UNITED STATES
DEPARTMENT OF THE INTERIOR
BUREAU OF LAND MANAGEMENT

FORM APPROVED
OMB NO. 1004-0137
Expires: January 31, 2018**SUNDRY NOTICES AND REPORTS ON WELLS**
Do not use this form for proposals to drill or re-drill an abandoned well. Use form 3160-3 (APD) for such proposals.5. Lease Serial No.
NMNM27506

8. Well Name and No.
SD EA 29 FED COM P8 10H9. API Well No.
30-025-43269-00-X110. Field and Pool or Exploratory Area
WC025G06S263319P-BONE SPRING11. County or Parish, State
LEA COUNTY, NM**SUBMIT IN TRIPLICATE - Other instructions on page 2**

CHEVRON respectfully requests the ability to change the BOPE rating for the subject well, from a 5M system to a 10M system while drilling the production sections that penetrate the Wolfcamp formation. (All intermediate sections, which TD in the Bone Spring, will have the previously submitted 5M system setup).

10M BLOWOUT PREVENTER SCHEMATIC

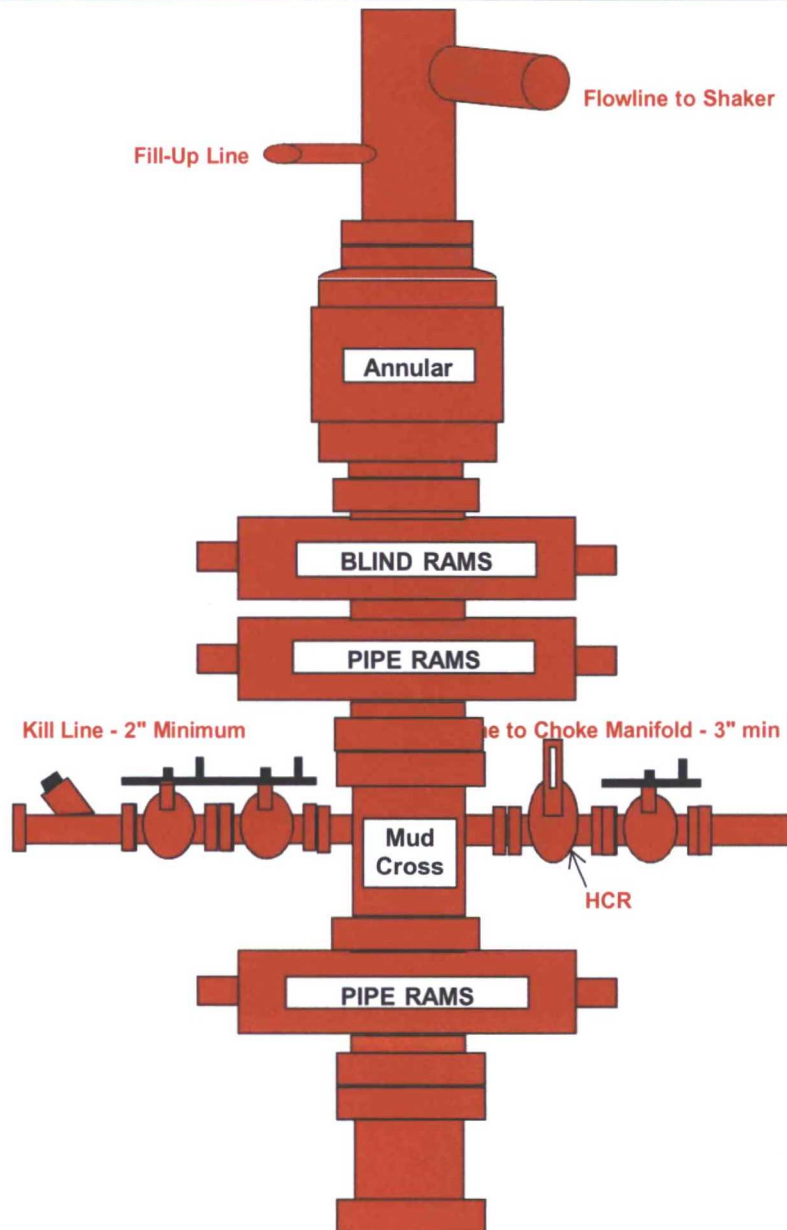
*All equipment will be 5M as per the original submittal, but the annular will be 10M, as well as the necessary upgrades to the choke manifold. (Upgrade 2" choke lines to 3" with a third choke).

10M Choke Manifold SCHEMATIC

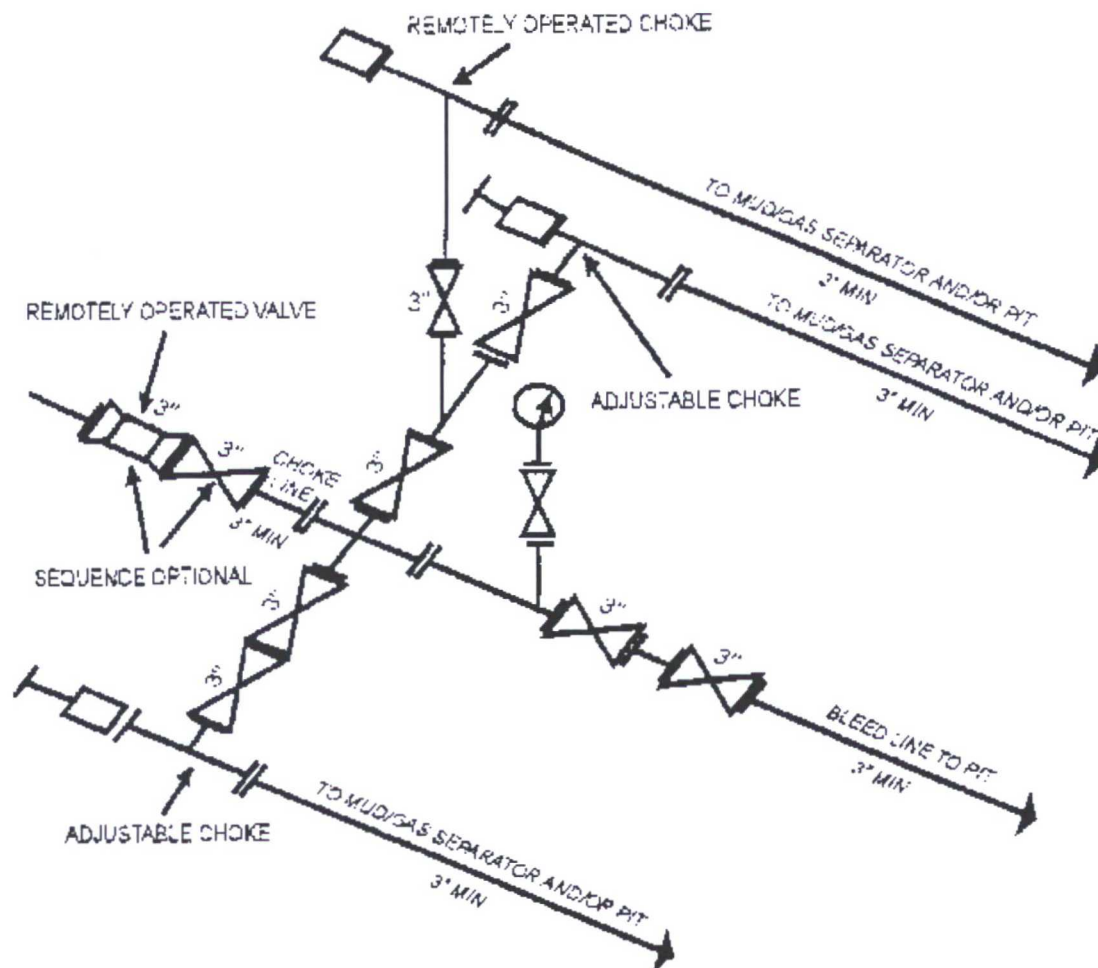
Please find attached, the 10M BOP choke schematic.
